NRA ADDENDUM TO

TD 16/93

GEOMETRIC DESIGN OF ROUNDBABOUTS

Standard TD 16/93 – Geometric Design of Roundabouts – is applicable in Ireland with the following amendments:

Figure 7/15

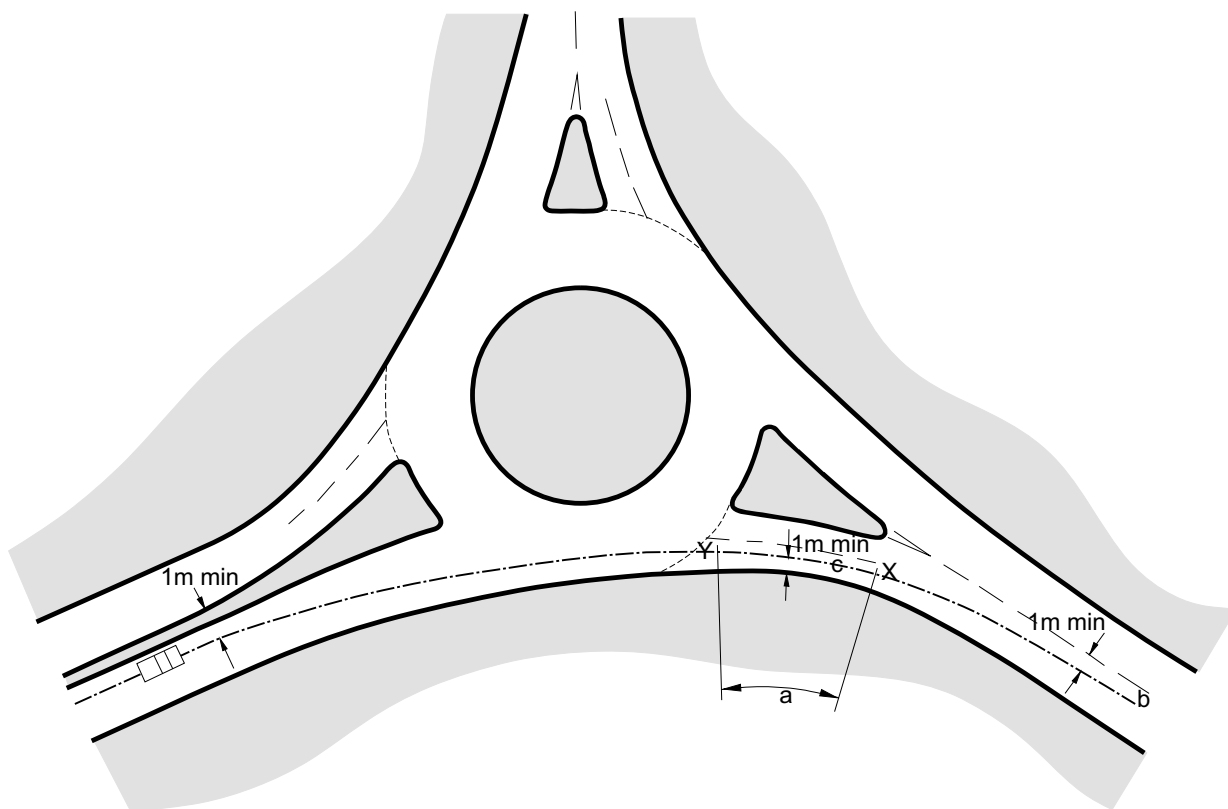
1.10 Page 7/10, Figure 7/15, note b:

For: “D2”

Read: “D2L (dual 2-lane)”

Measurement of Stopping Sight Distance
 Figure 7/19

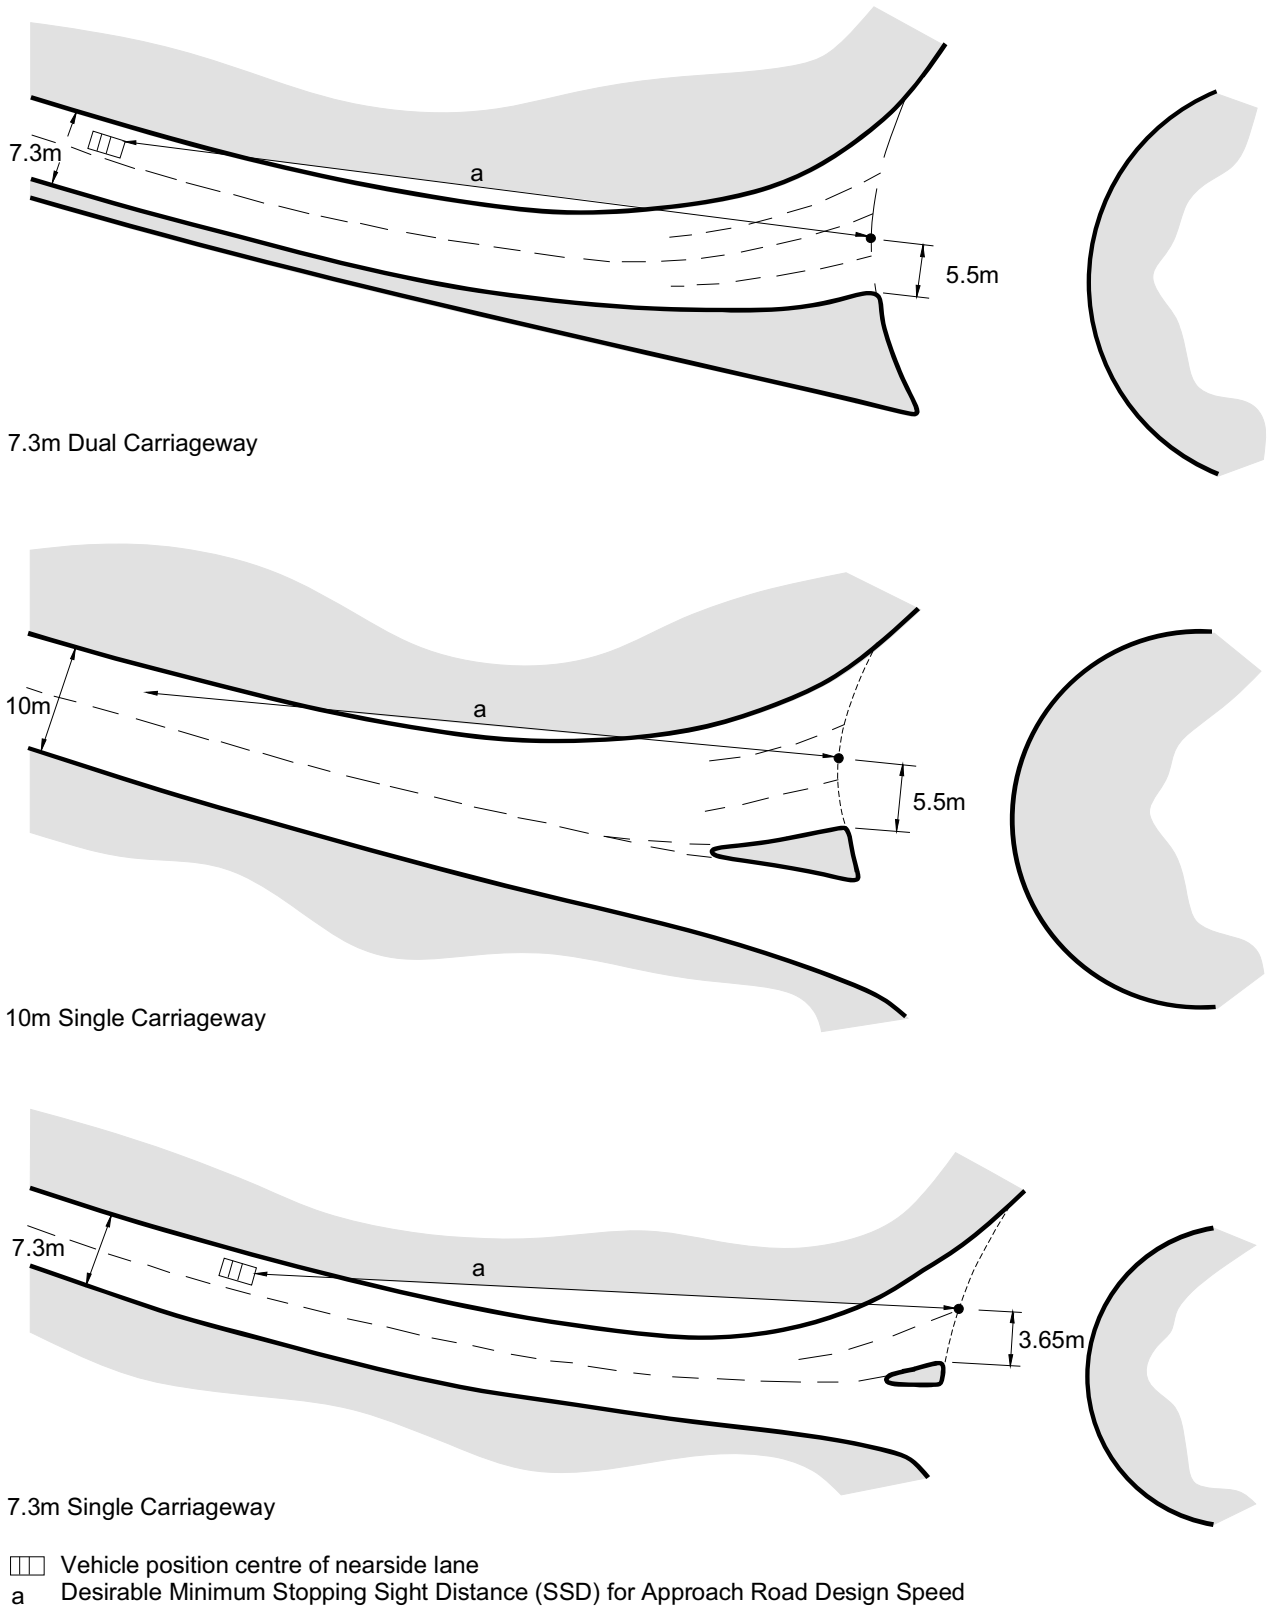
- 1.11 Page 7/11, Paragraph 7/34, line 9:
For: "the Traffic Signs Regulations and General Directions."
Read: "the Road Traffic (Signs) Regulations."
- 1.12 Page 7/13, Figure 7/19, top (7.3m Dual Carriageway):
For: "7.3m" (two locations)
Read: "7.5m or 7.0m".

- 1.13 Page 7/13, Figure 7/19, bottom (7.3m Single Carriageway):
For: "7.3m" (two locations)
Read: "7.5m or narrower".
- 1.14 Page 7/14, Table 7/1, second column:
For: "Fig 7/20a"
Read: "Figures 7/20, 7/21 and 7/22".

Figure 7/20b

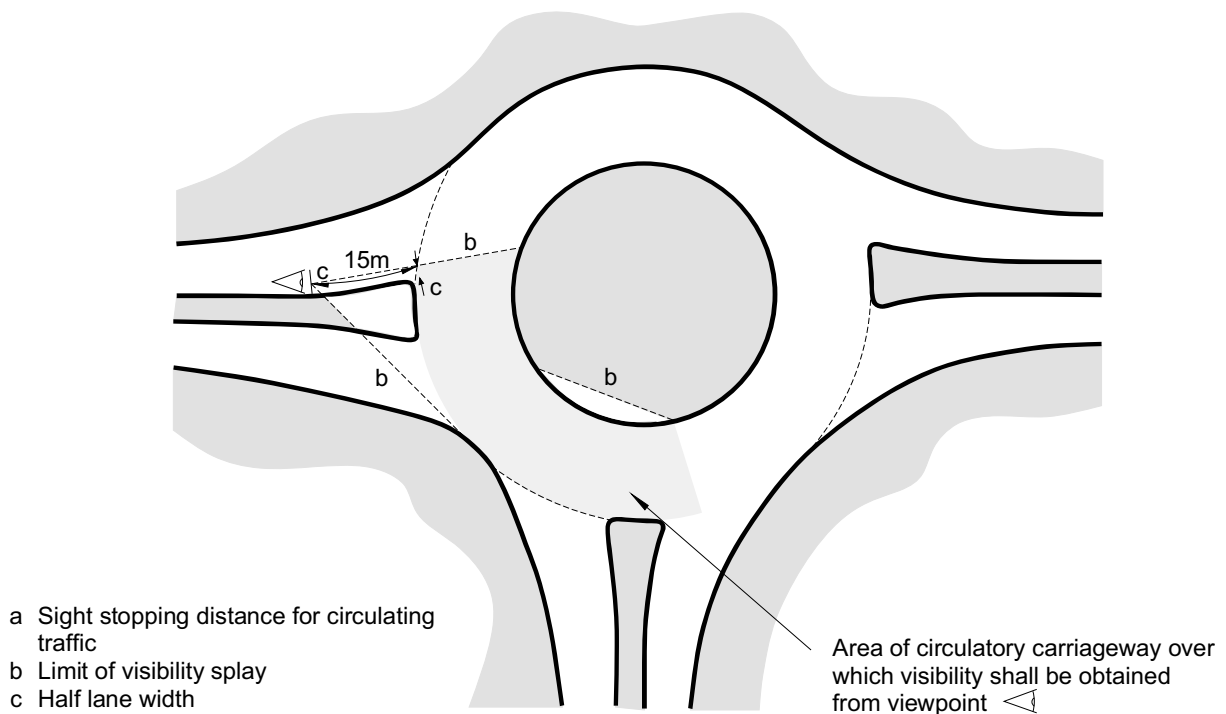
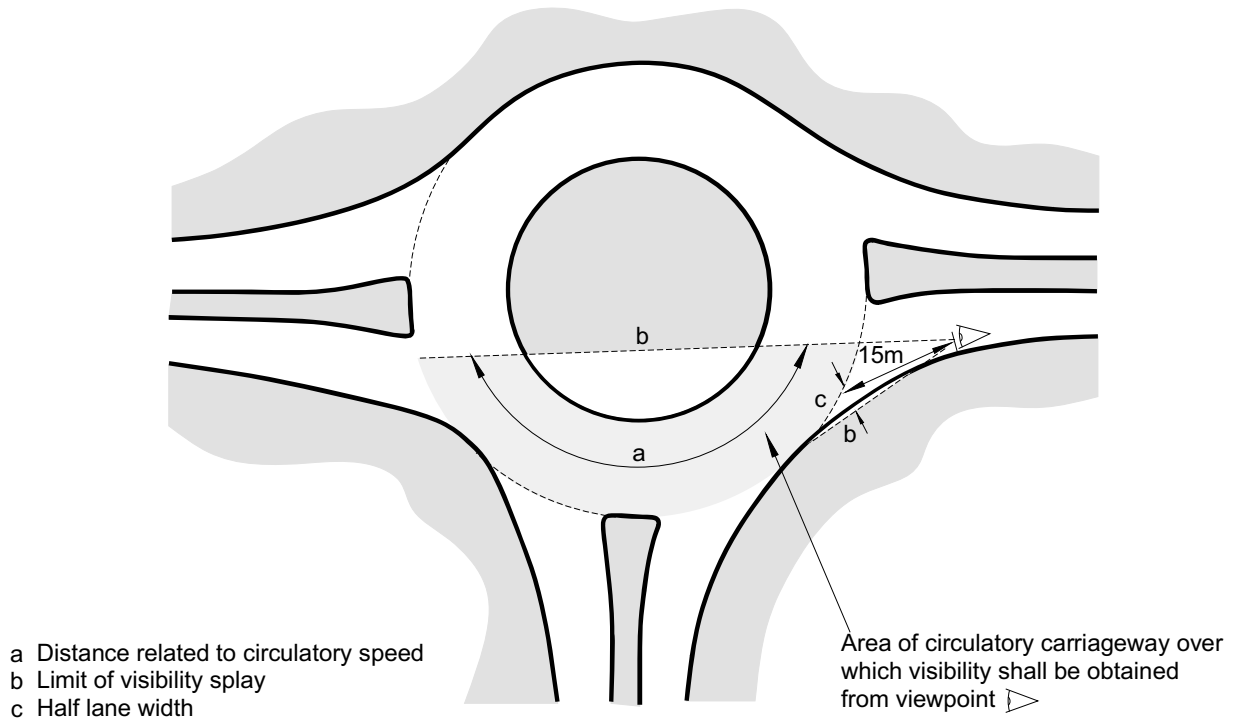
- 1.15 Page 7/15, Figure 7/20b:
Insert dimension a on circulatory carriageway in the same location as in Figure 7/20a.
- 1.16 Page 7/16, Figure 7/21, notes and Figure 7/22, notes:
For: "a. Distance related to circulatory speed" (two locations)
Read: "a. Stopping sight distance for circulatory traffic."
